SITE PLAN REVIEW

Project Name: Cactus Cooking

FILE #SPR-96-83

TITLE HEADING: Cactus Coatings - 4,500 s.f. addition

Cactus Coatings, Inc. Landscape & Parking Plan

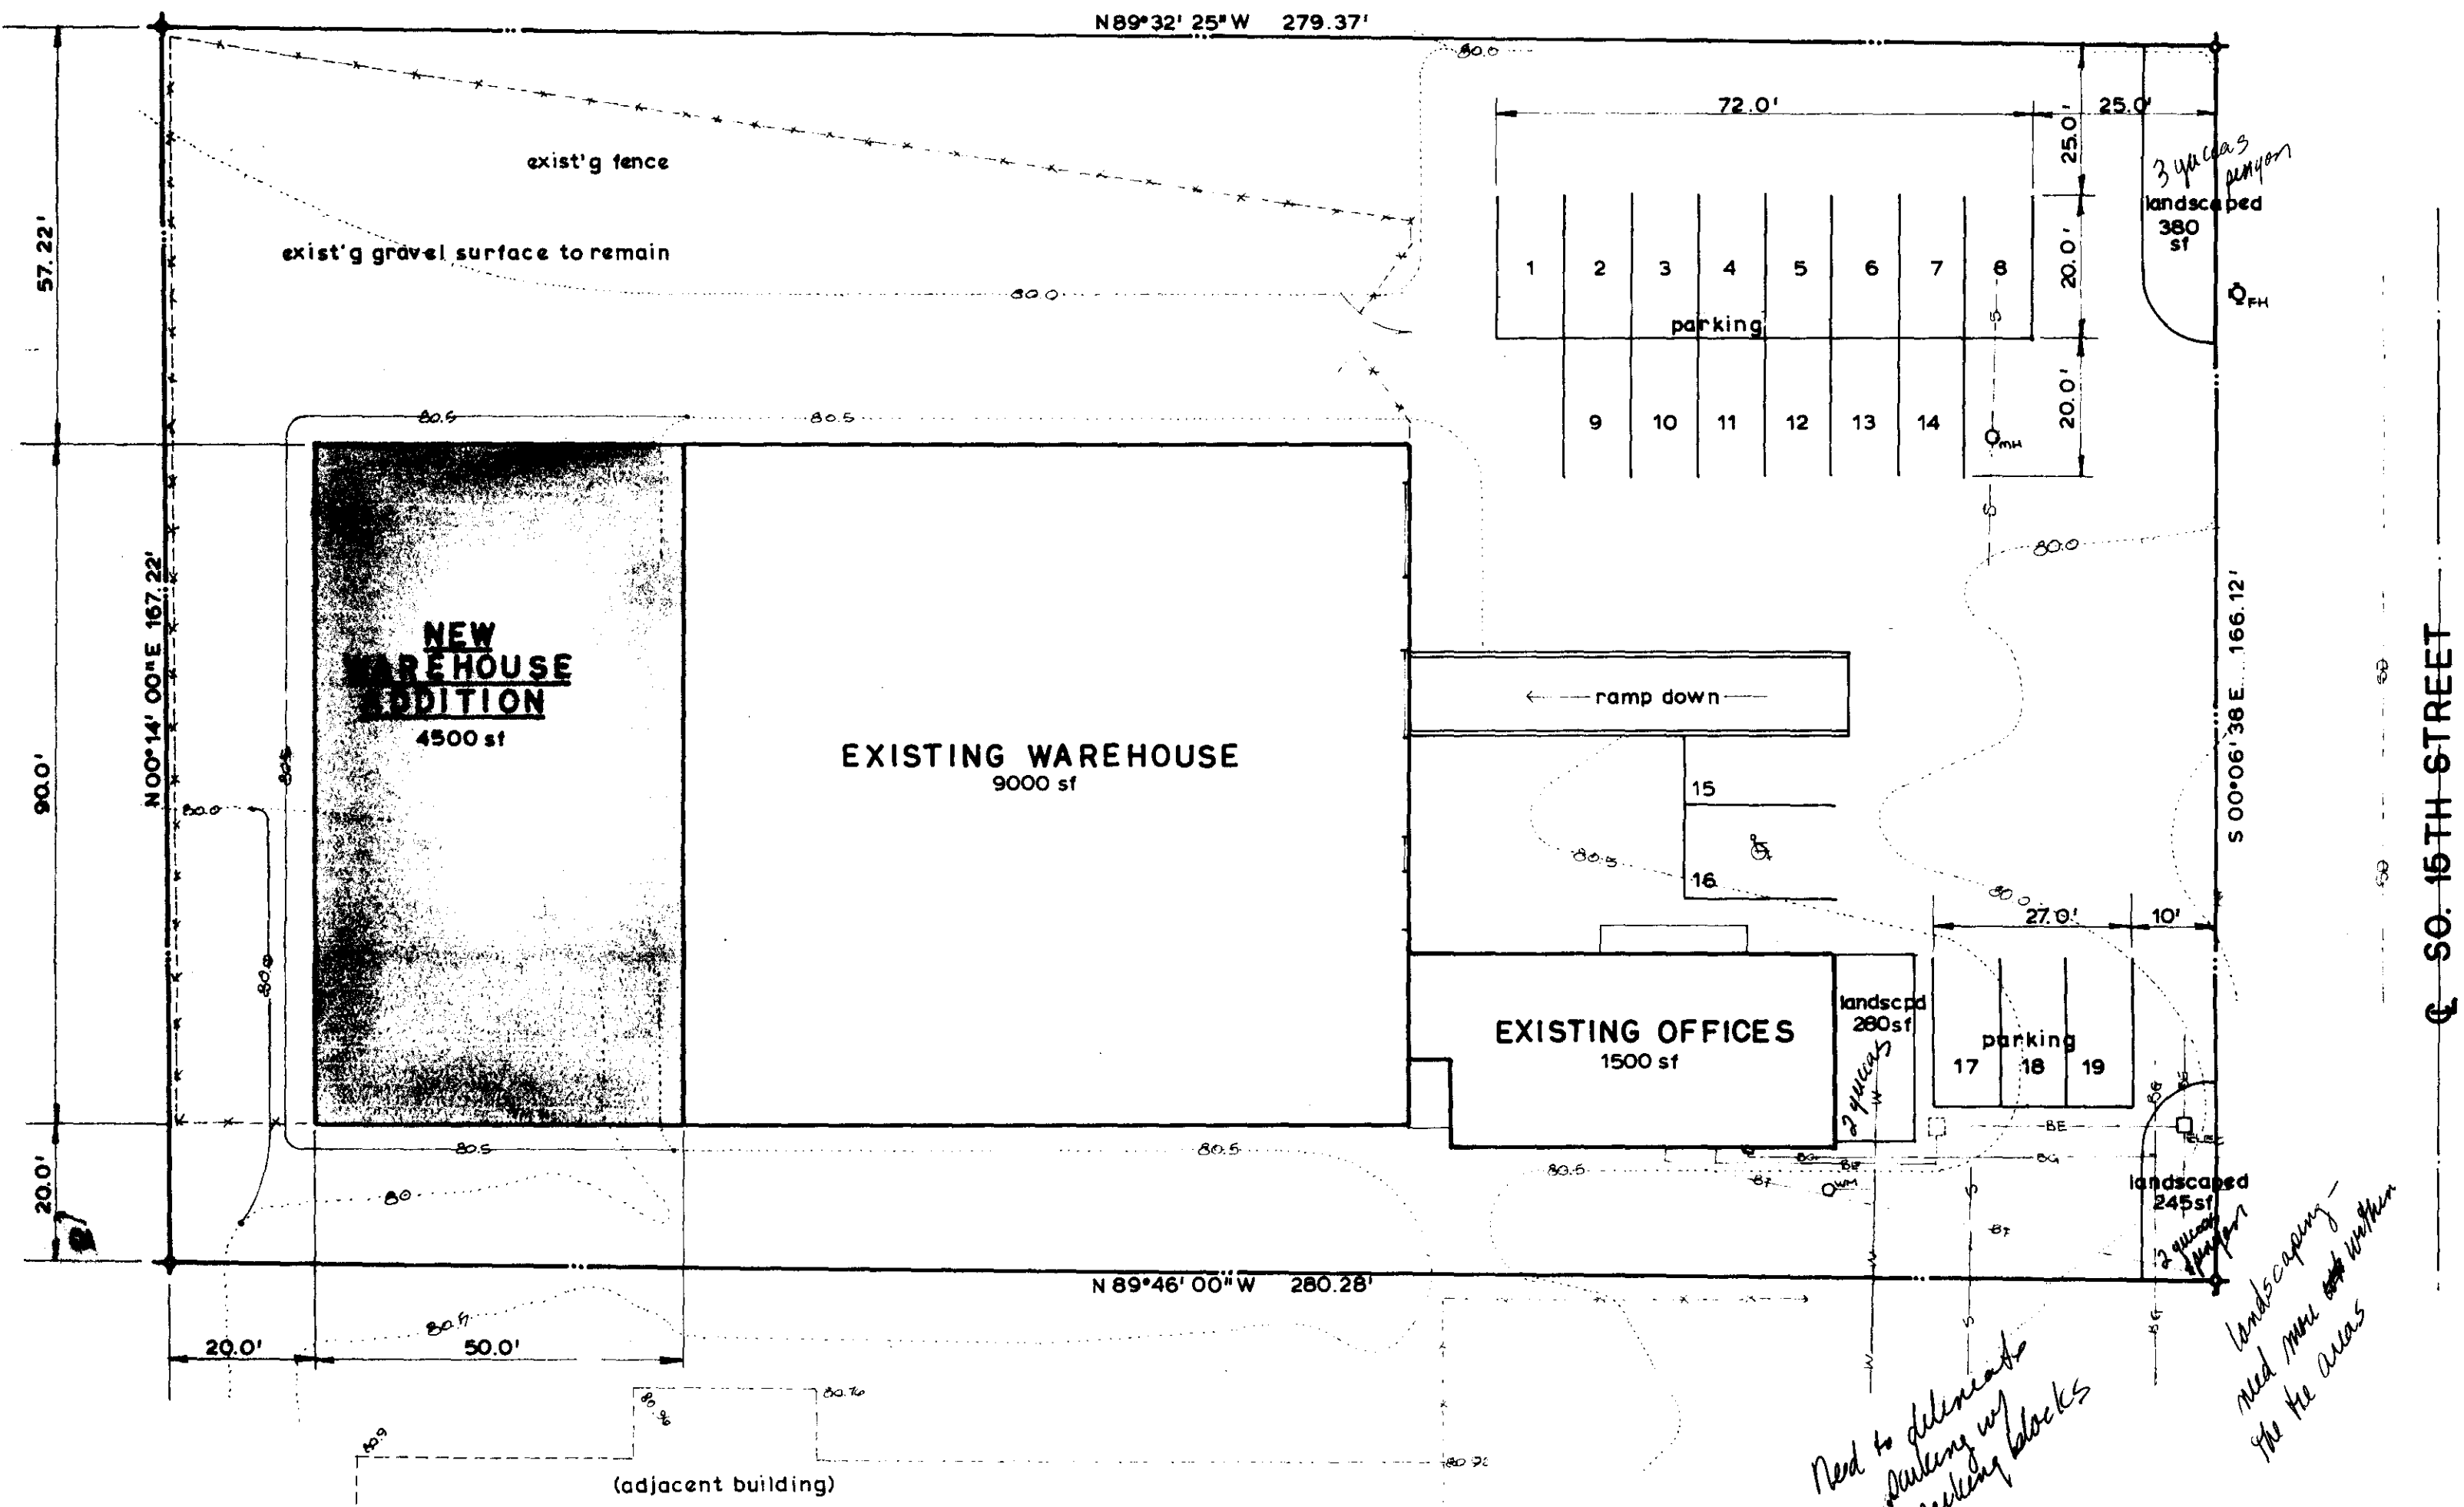
1. To calculate the total parking required please provide the number of employees on the largest shift. The parking requirement is one space per employee on the largest shift, plus 10% of total employee stalls for visitor parking, plus one space for each vehicle used in the operation of the business.

2. The parking as shown on the site plan must be delineated on-site through the use of parking blocks or striping if the area is to be paved.
3. The total landscaped area required is 622 s.f. 905 s.f. of area is shown on the plan. A site visit showed that all of the square footage shown as landscaped is not. The area at the SE corner has 2 yuccas and 1 small pinon pine. The area at the NE corner has 3 yuccas and 1 small pinon pine. The area in front of the building has 2 yuccas and one flowering plant. Revise the drawing to show the detail on those landscaped areas with what's existing and what's proposed to meet the 40% shrub coverage requirement. All landscaped areas are required to have an underground, pressurized irrigation system.

Need to delineate parking w/ parking blocks

landscaping - need more within the areas

Additional employees
